## NOVI TOWN CENTER BUILDING X.1 SITE PLAN 10-41A

Consideration of the request of Novi Town Center Investors, LLC, for a recommendation to City Council for Preliminary Site Plan approval. The subject property is located in Section 14 near the northwest corner of Eleven Mile Road and Town Center Drive, in the TC, Town Center District. The subject property is approximately 35.7 acres and the applicant is proposing to construct an approximately 17,500 square foot retail building to connect the existing Novi Town Center to the proposed Walmart store.

### Planning Review of Preliminary Site Plan

Novi Town Center – Building X.1

# NOVI TOWN CENTER POST RE-DEVELOPMENT MASTER PLAN

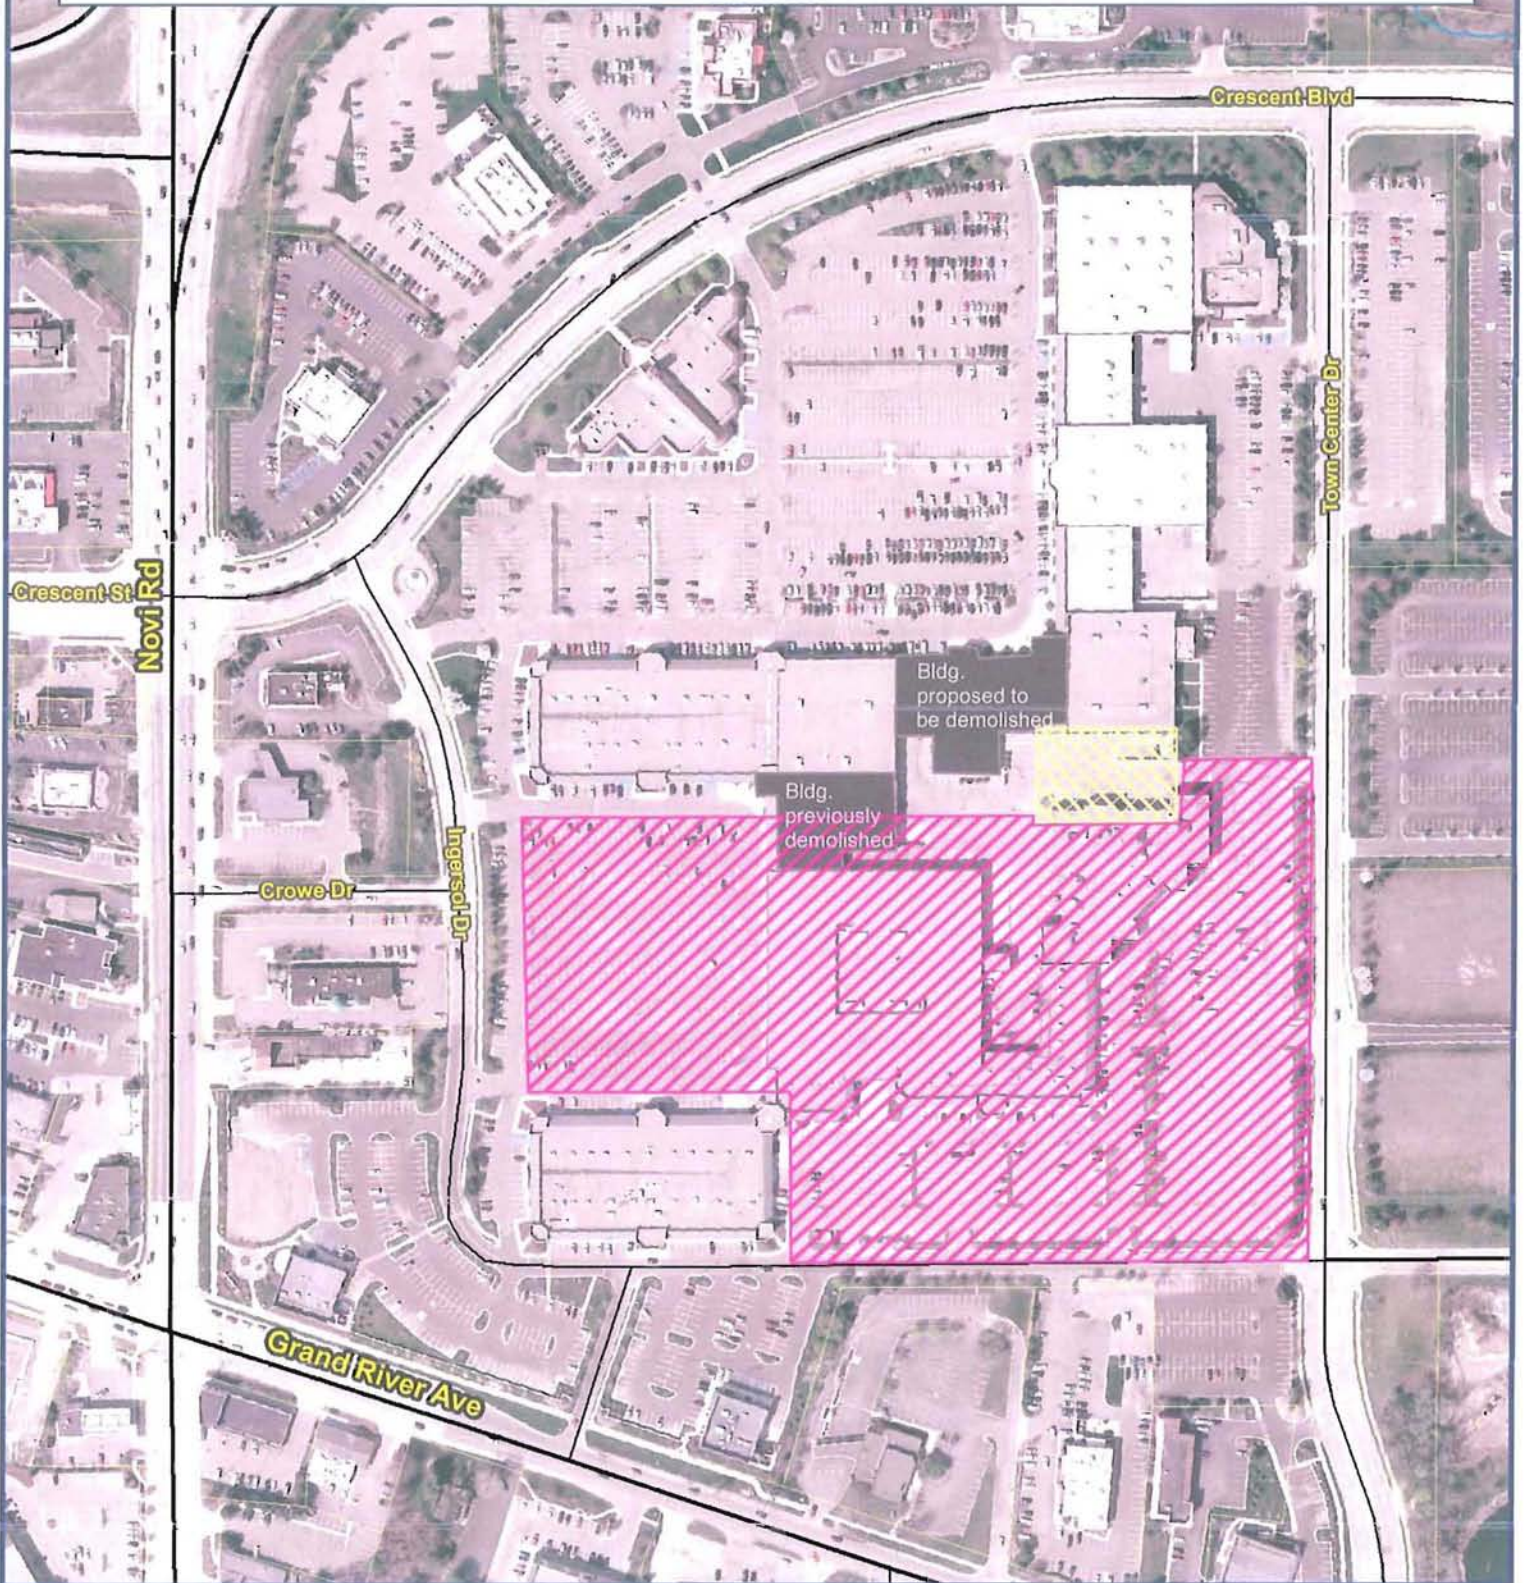
9. Site Plan: **Please provide a sheet titled "site plan" showing the proposed exterior changes using an engineer's scale.**
10. Parcel Split: At this time, no property combination or split has been submitted and the Planning Division has not received a request for condominium approval that would affect the subject property. The applicant must create this parcel prior to Stamping Set approval. Plans will not be stamped until the parcel is created.

9. The name of sheet A 1.1 will be changed to Site Plan in lieu of Master Plan. A dash line will also be added to indicate the buildings being demolished.
